MEMORANDUM

To: The Design Advisory Board
From: Mary O'Neil, AICP, Senior Planner MOneil
RE: ZP 15-0468CA; 166 East Avenue
Date: October 28, 2014

File: ZP 15-0468CA
Location: 166 East Avenue
Zone: RL **Ward**: 1
Date application accepted: October 6, 2014
Applicant/ Owner: Germain Mopa
Request: Addition to existing duplex.
Estimated Construction Cost: $205,000
Background:

1926 Sanborn detail

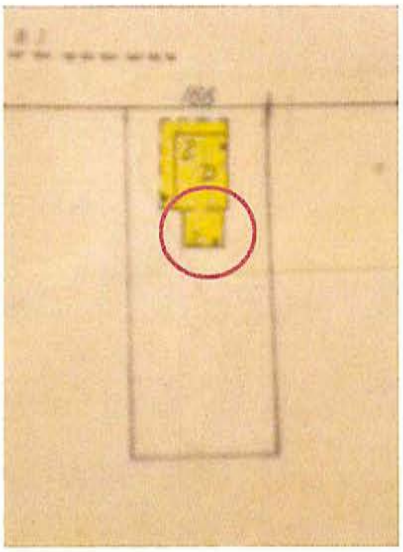
This is an application to replace an existing structural addition with a much larger building volume. The rear addition is identified on the 1926 Sanborn Map. It retains the apparent original garage doors, which are noted in the Vermont State Register listing (see attached.) The addition is located behind the original dwelling, and extends into the rear of the lot.

Existing street view of 166 East Avenue.
Note visibility of rear addition area from the street.

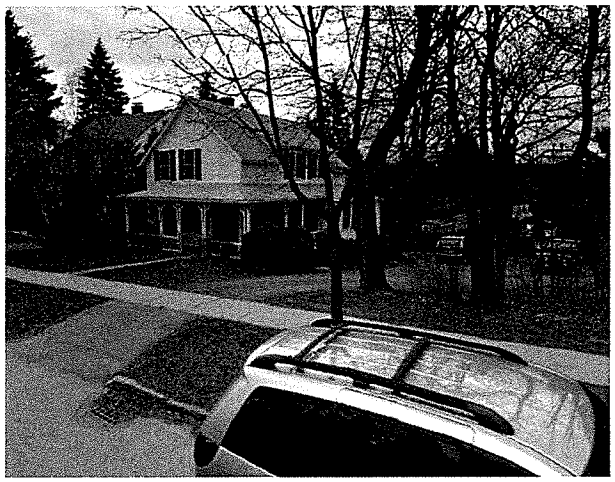
Although the proposed addition is proposed to be attached to the rear of an existing dwelling, it will remain highly visible from the public way due to its mass and volume.

Remove this former addition

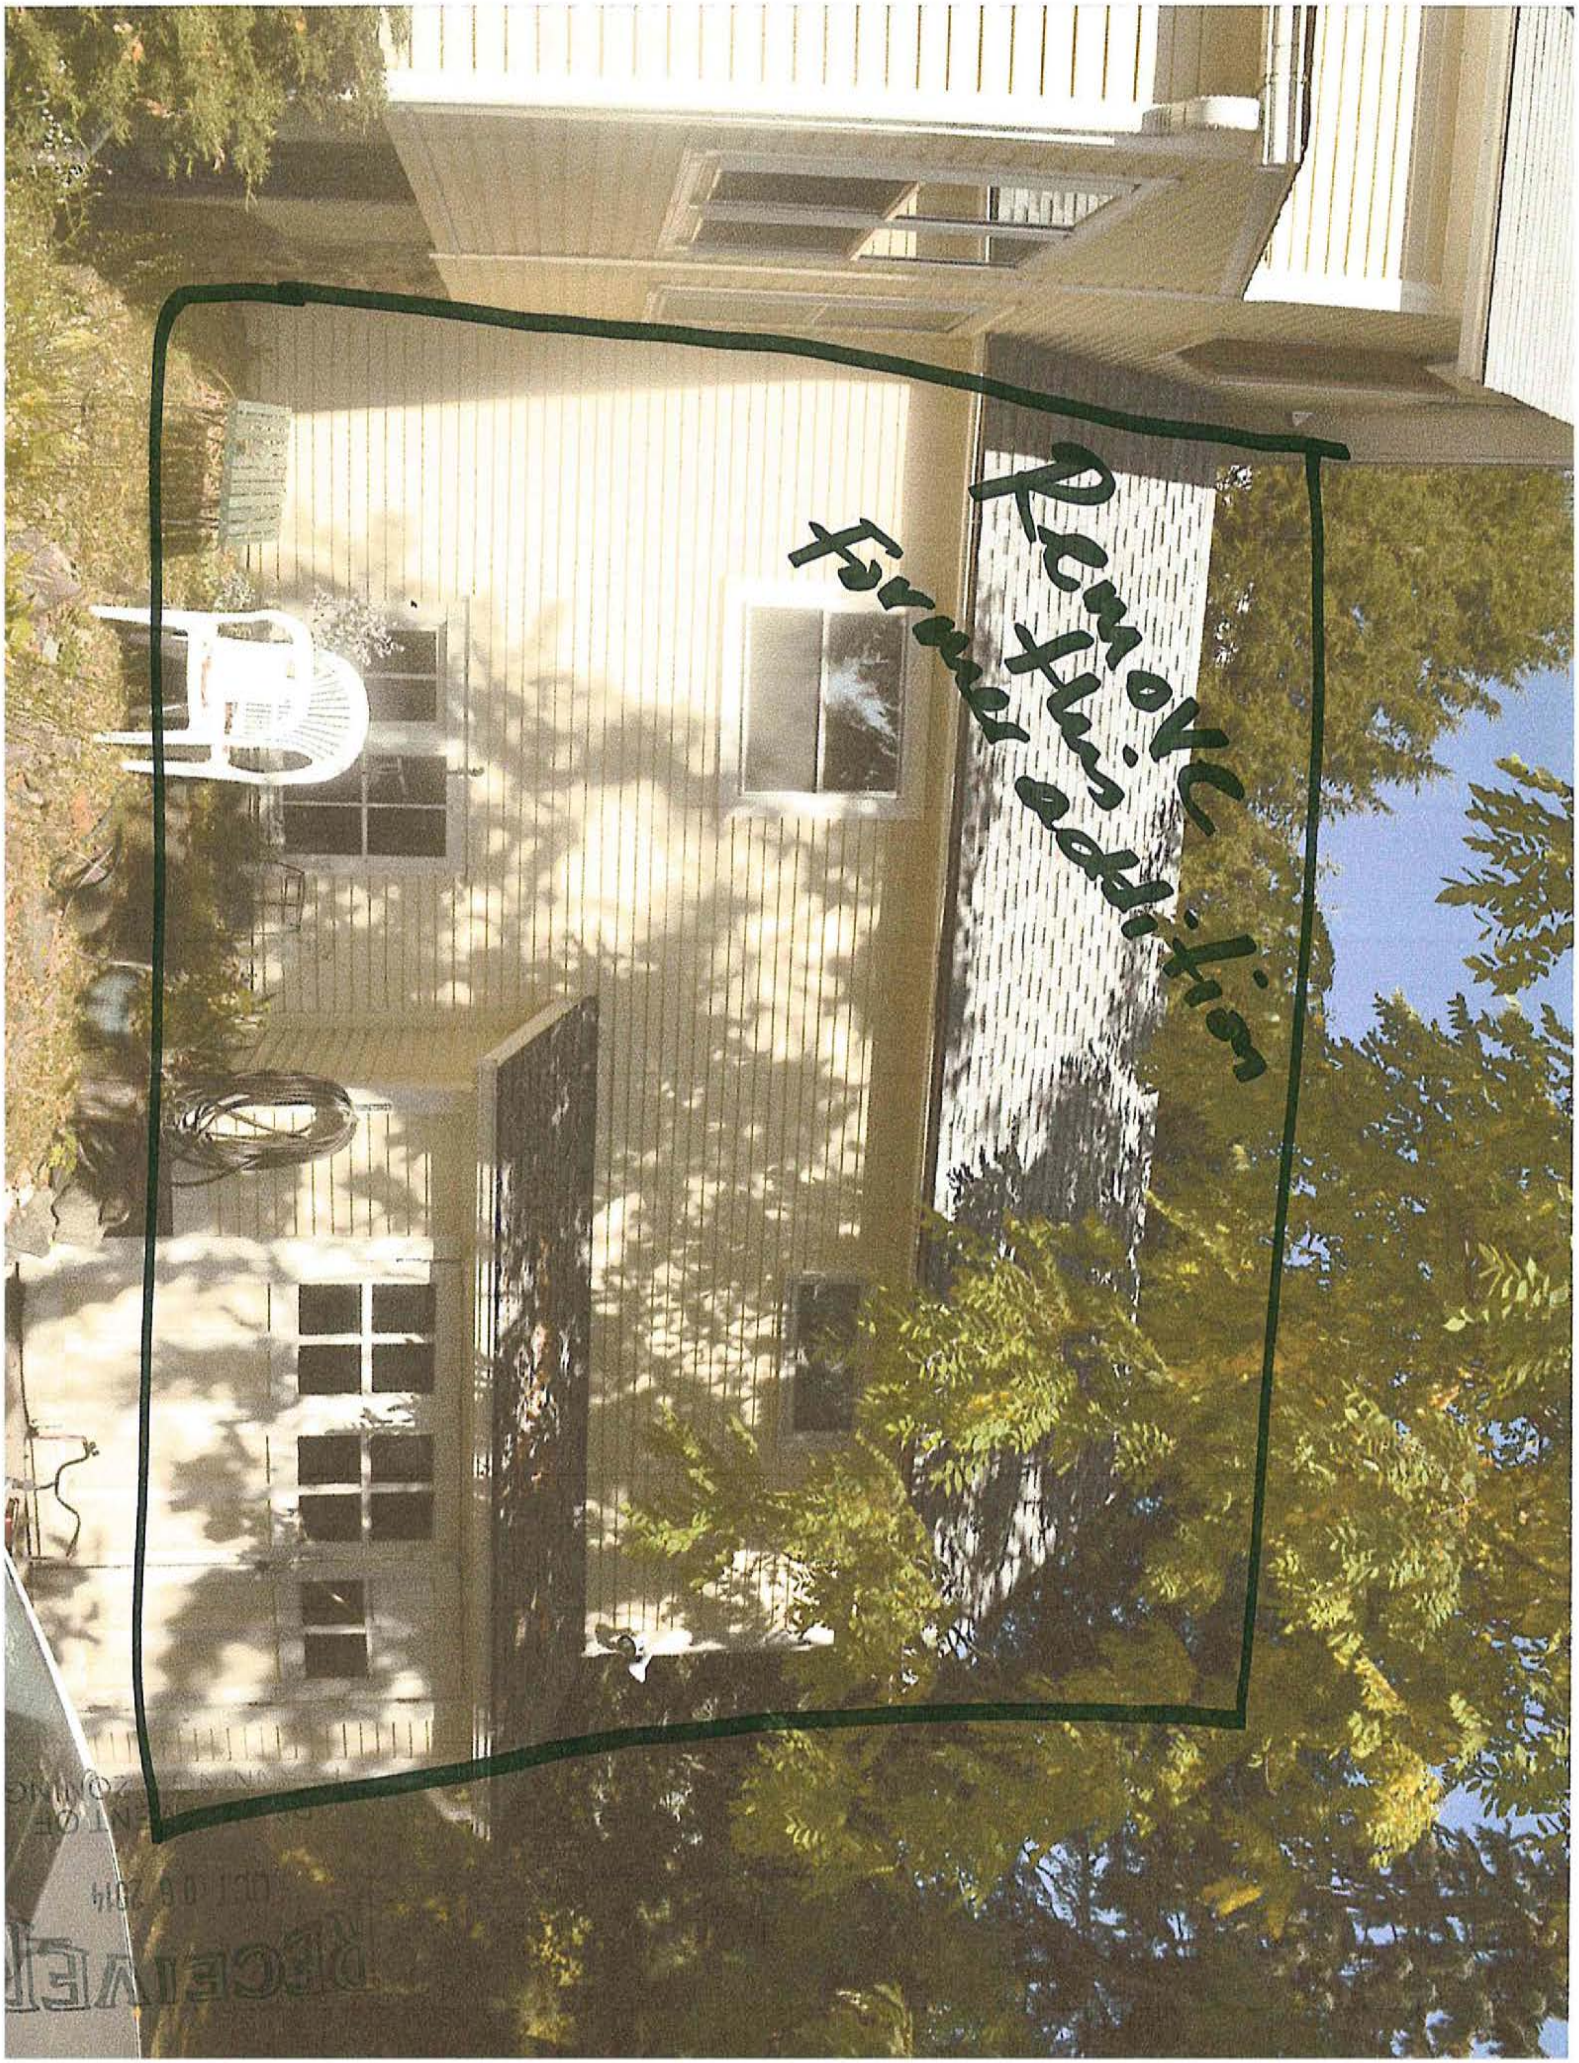
The rear addition, constructed prior to 1926, has historic significance in its own right and should be considered for retention. Of special merit are the garage shed and doors, which appear to be original and contribute to the character of the structure.

The demolition of a noteworthy addition is the most adverse of physical treatments, and is not advised under this standard.

RIGHT SIDE VIEW - SOUTH

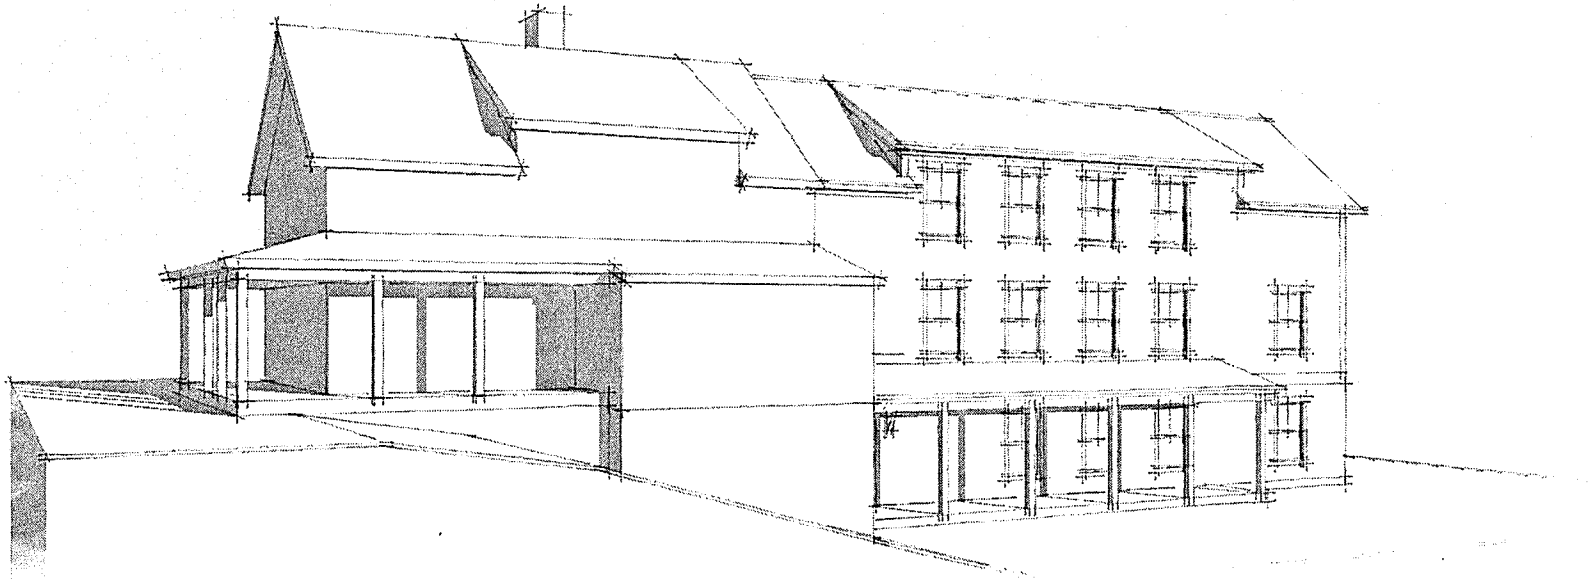
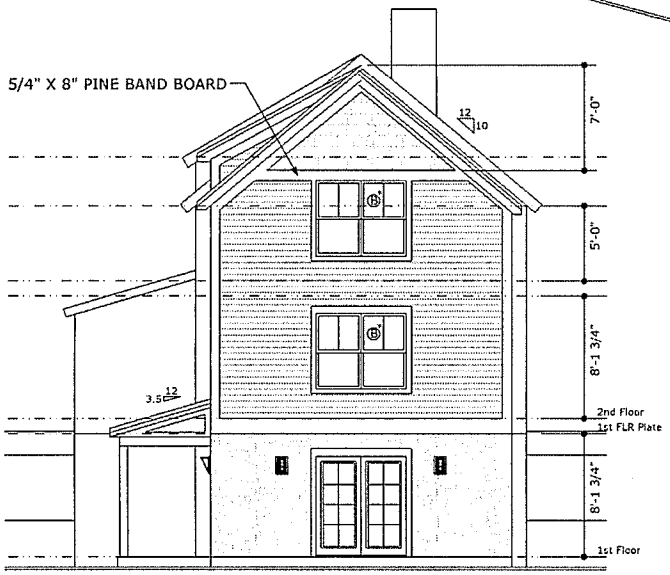
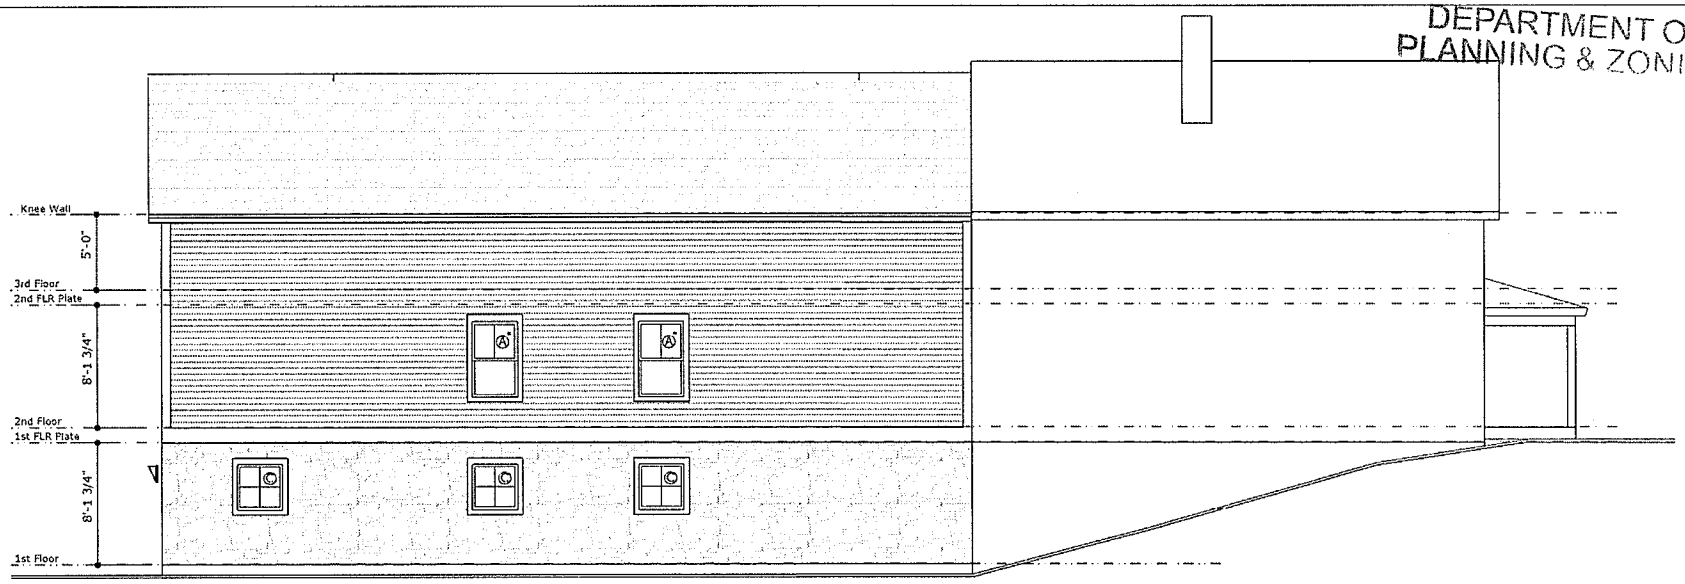
As illustrated in the modeling study, the building height may be technically inches less than the original house, but the large exposure coupled with the raised dormer roof visually increases the apparent height; in conflict with this standard.

A gabled roof is proposed, with a full height dormer on the south elevation. Both of these features are present on the existing house (although in much smaller scale.)

Window pattern on the southern elevation are rhythmic in their placement, and centered under the full dormer. Paired double hung sash are illustrated in the east elevation; the north elevation has only a handful of windows on the first and 2nd floor; none on the third. Presumably this is to provide privacy from the immediate neighbors.

Plans define materials thus: "Siding, trim, gable and eave details to match existing." The Assessor's files define existing materials as wood clapboard with an asphalt shingle roof. The applicant will need to confirm proposed materials.

SITE PLAN.

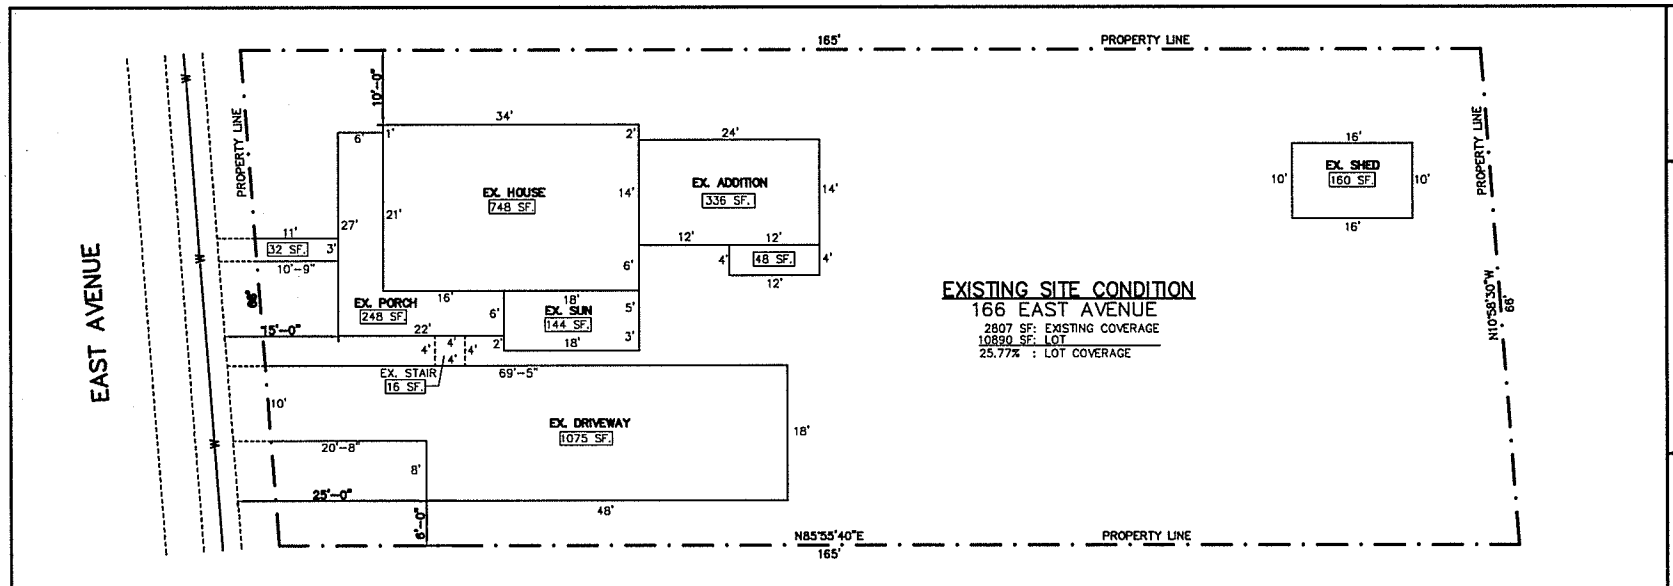
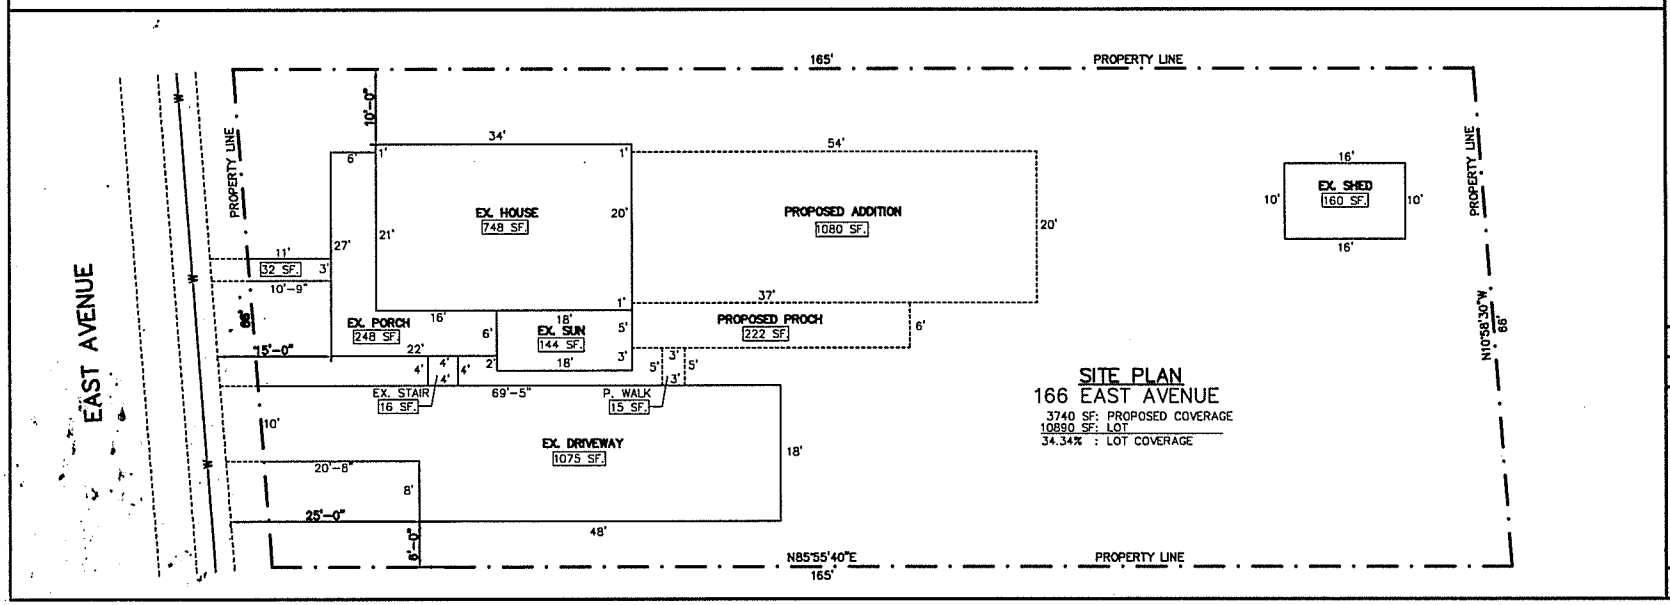
This is an existing duplex with a single curb cut. The site plan proposes no change from the existing; however aerial photos do not match the existing driveway/parking pattern that is illustrated on the site plan. See comments about parking, below.

The submitted site plan for existing conditions does not match aerial and historic ortho views of the parking pattern on the property. Since 1978, it is clear that the parking has moved away from a circulation pattern to the rear garage, toward a curved pattern that appears to cross property lines to the south.

The "existing" parking plan is not factual on the submission, and the expanded parking area has not been permitted. The submission materials will have to be amended to reflect actual conditions and the applicant is challenged to provide permits that demonstrate approval for the parking area. Absent permits, the site will need to be returned to its configuration prior to 1999.

As a duplex, only 4 parking spaces are required. The large parking area illustrated is excessive for the use, and it does not appear to have been permitted via the zoning process. It certainly seems to extend beyond the property boundaries.

The proposed parking area appears to accommodate a significant number of vehicles, which may require appropriate shading per this standard. The applicant will be required to show individual parking spaces, meeting appropriate back-up length and required landscaping on the site plan.

2. The applicant will be required to demonstrate approved permit(s) for the expanded parking area.
3. The proposed parking area appears to accommodate more than 5 vehicles, which may require appropriate shading. The applicant will be required to show **individual parking spaces**, meeting appropriate back-up length and any required landscaping on the site plan. See Section 6.2.2. (l).
